Project	IEEE 802.16 Broadband Wireless Access Working Group < http://ieee802.org/16 >	
Title	Revision of LDPC to accommodate HARQ	
Date Submitted	2004-05-11	
Source(s)	Mark Cudak, Brian Classon, Motorola Inc. Valentine J. Rhodes, Intel Corporation	Mark.Cudak@motorola.com Brian.Classon@motorola.com valentine.j.rhodes@intel.com
Re:	Ballot #14a	
Abstract	This contribution proposes text to allow recently defined features such as HARQ and AMC sub channels to operate with LDPC and other coding modes.	
Purpose	Adoption	
Notice	This document has been prepared to assist IEEE 802.16. It is offered as a basis for discussion and is not binding on the contributing individual(s) or organization(s). The material in this document is subject to change in form and content after further study. The contributor(s) reserve(s) the right to add, amend or withdraw material contained herein.	
Release	The contributor grants a free, irrevocable license to the IEEE to incorporate material contained in this contribution, and any modifications thereof, in the creation of an IEEE Standards publication; to copyright in the IEEE's name any IEEE Standards publication even though it may include portions of this contr

Figure eee—Construction of H-ARQ encoder packet

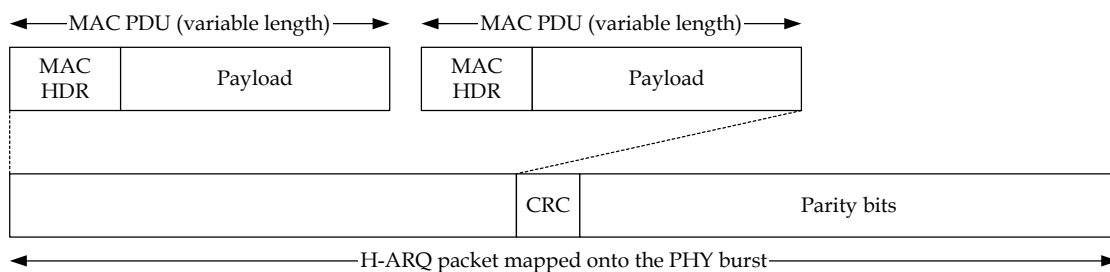
Modify Section 6.4.17 "MAC support for HARQ" after figure 125

Hybrid automatic repeat request (H-ARQ) scheme is an optional part of the MAC and can be enabled on a per-terminal basis. The per-terminal H-ARQ and associated parameters shall be specified and negotiated during initialization procedure. A terminal cannot have a mixture of H-ARQ and non-H-ARQ traffic. One or more MAC PDUs can be concatenated and an H-ARQ packet formed by adding a CRC to the PHY burst. Figure eee shows how the H-ARQ encoder packet is constructed.

The two main variants of H-ARQ are supported, Chase Combining or Incremental Redundancy (IR). For IR, the PHY layer will encode the H-ARQ packet generating several versions of encoded subpackets. Each subpacket will be uniquely identified using a subpacket identifier (SPID). For Chase Combining, the PHY layer will encode the H-ARQ packet generating only one version of the encoded packet. As a result, no SPID is required for Chase Combining.
